Technical Service Information

DODGE 68RFE CLUNK NOISE FROM DRIVE TO NEUTRAL

Figure 2

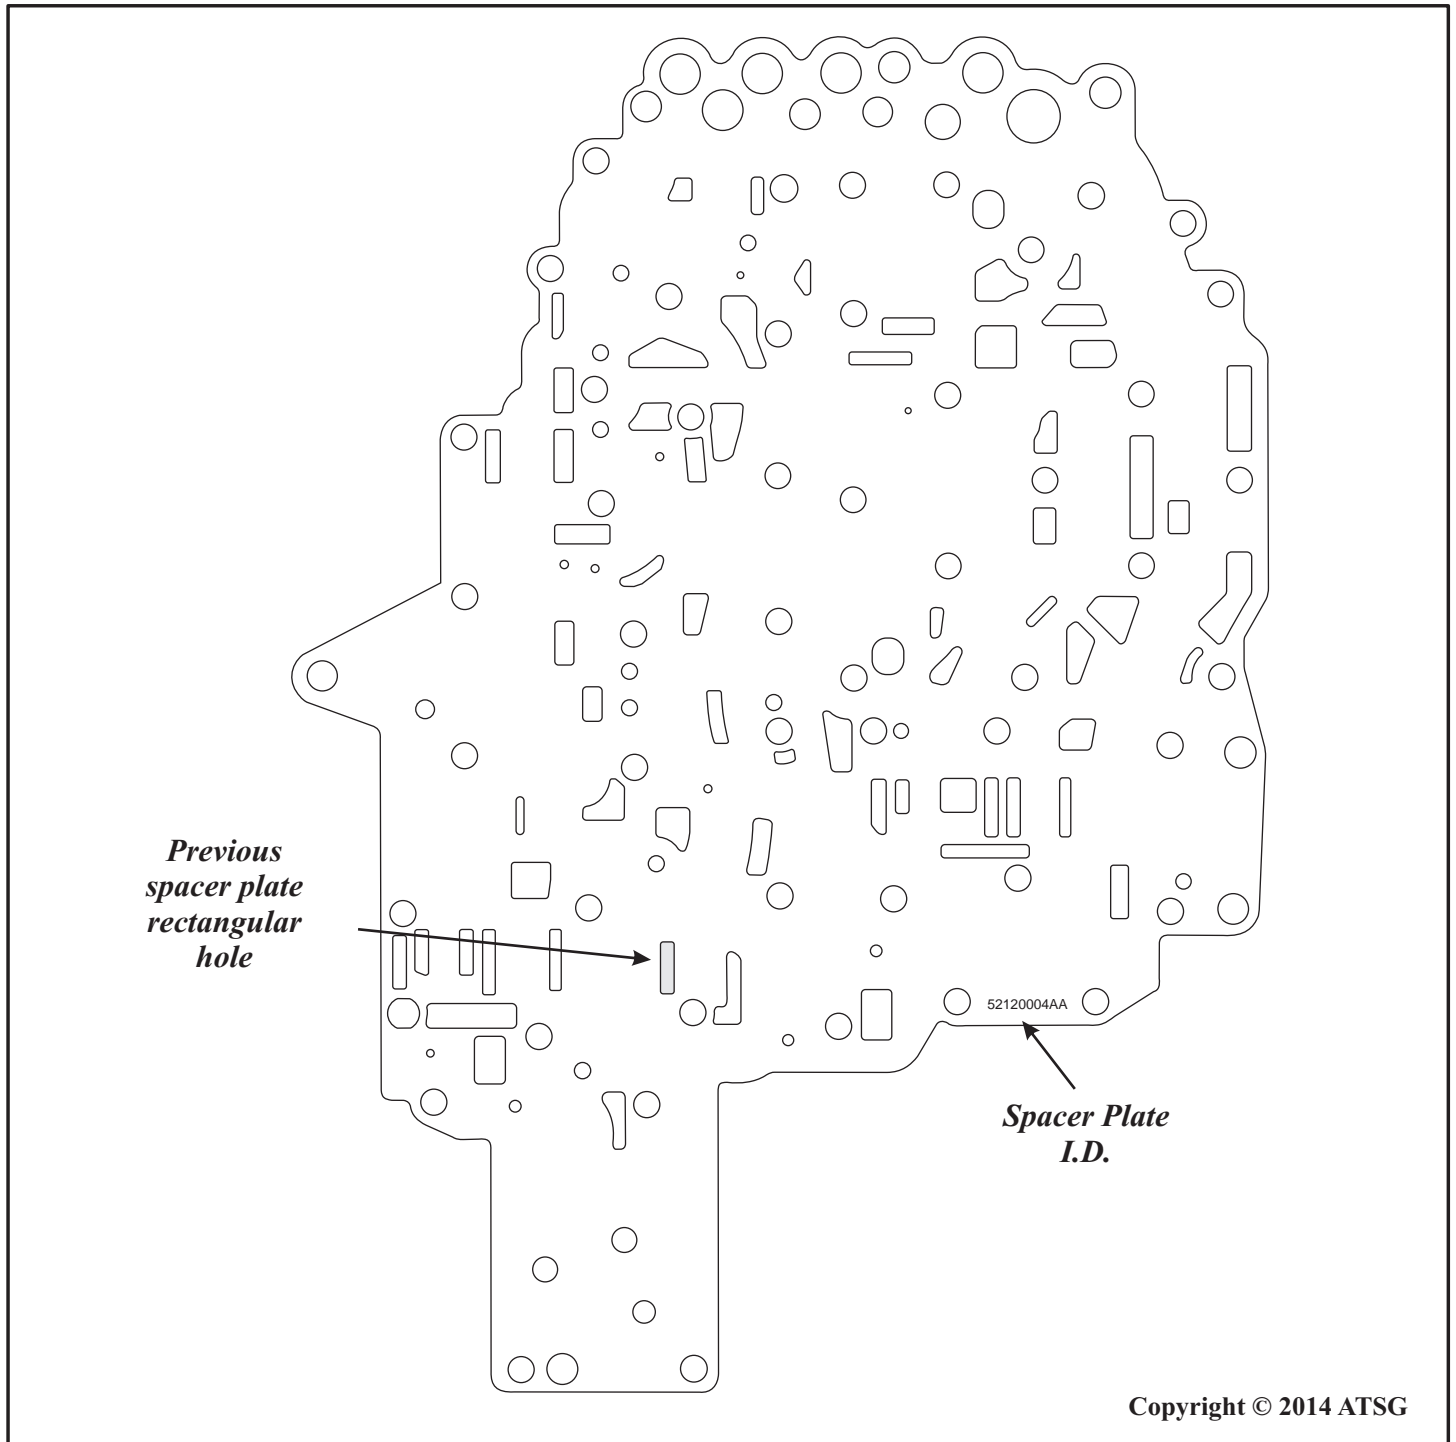
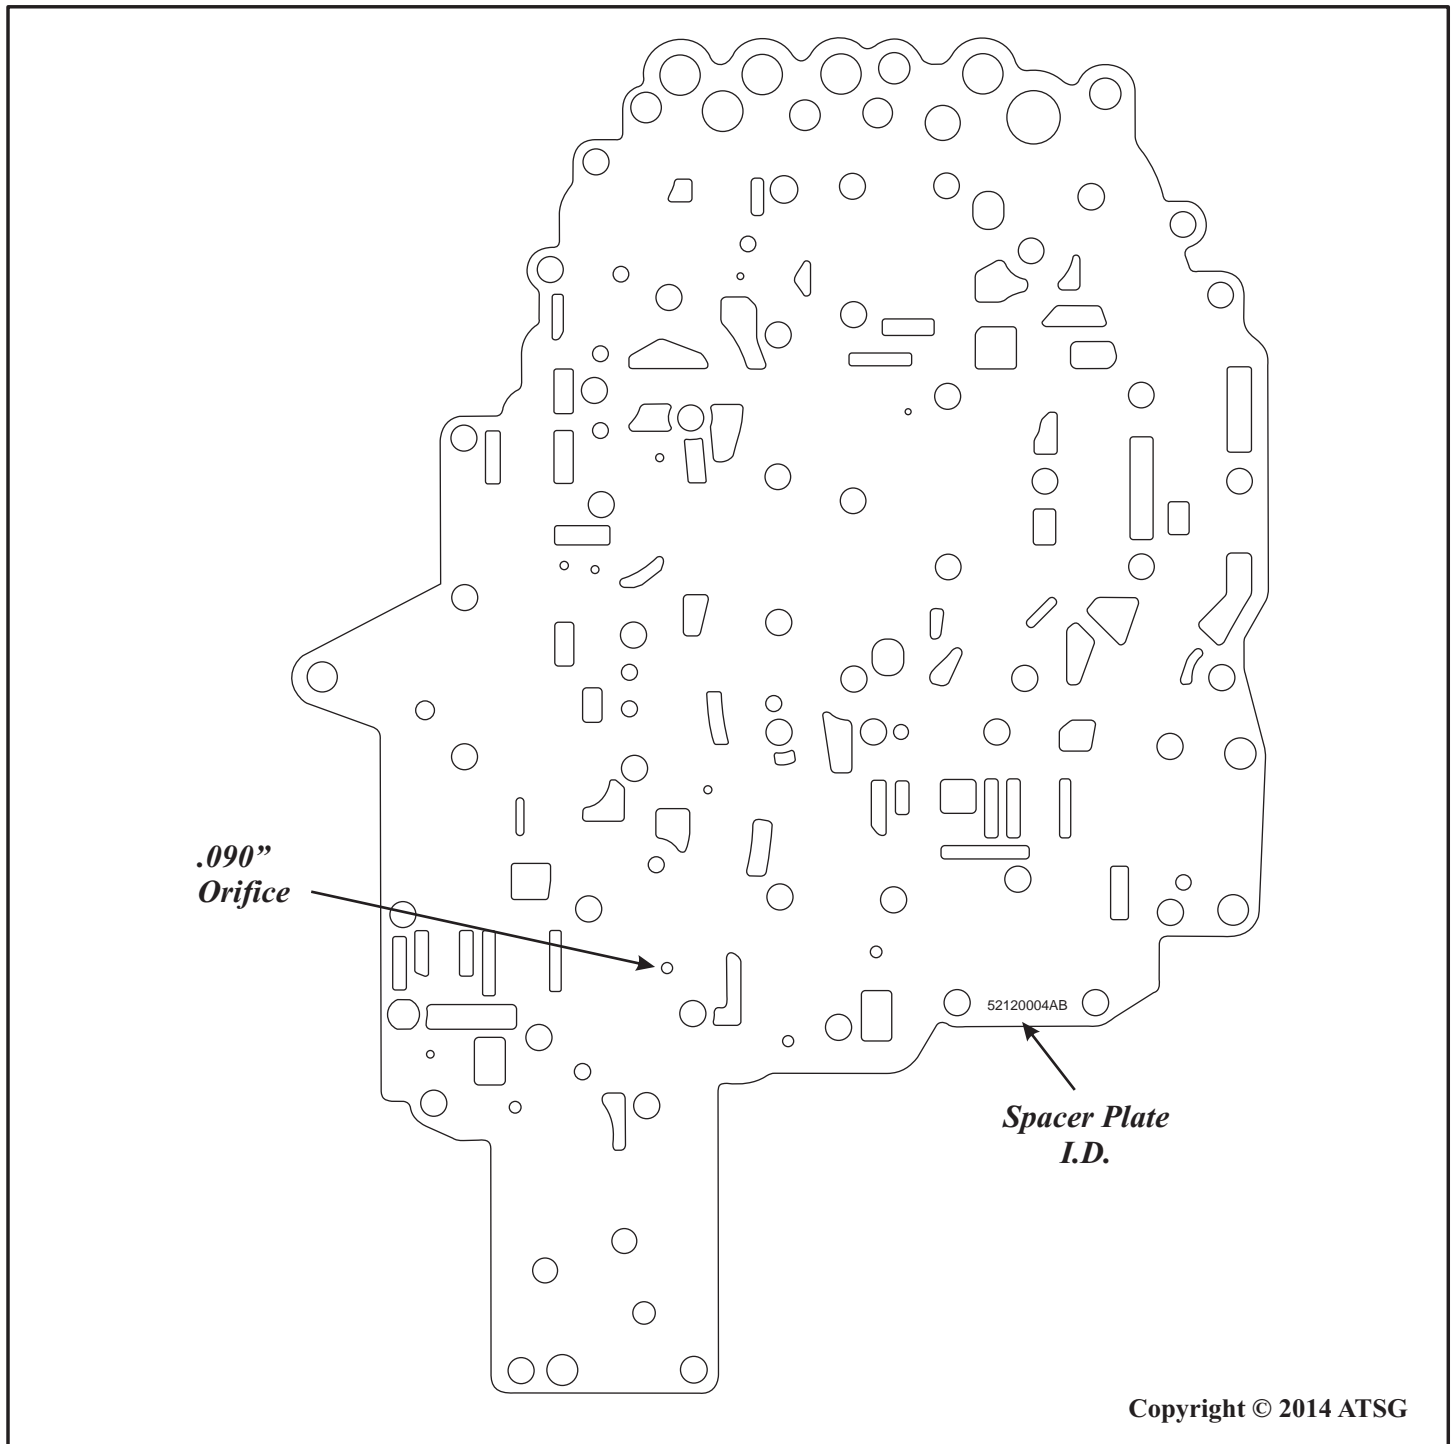
CORRECTION: To correct this condition, install the new design spacer plate as listed in service information below. This new spacer plate provides a .090" orifice to slow down the release of the Underdrive Clutch when the selector is moved from Drive to Neutral. See Figures 2 and 3 for the location of the exhaust in the spacer plate and for spacer plate I.D. number location. Note: This new spacer plate is only for 2011 and up models that do not use the number 6 and 7 check balls as shown in Figure 4. See Figure 5 for the location of the exhaust passage in the channel plate. Refer to Figures 6 and 7 to see the location of the orifice in an oil circuit diagram from the Drive position to the Neutral position.

VALVE BODY SPACER PLATE (Dodge part no.).....52120004AB
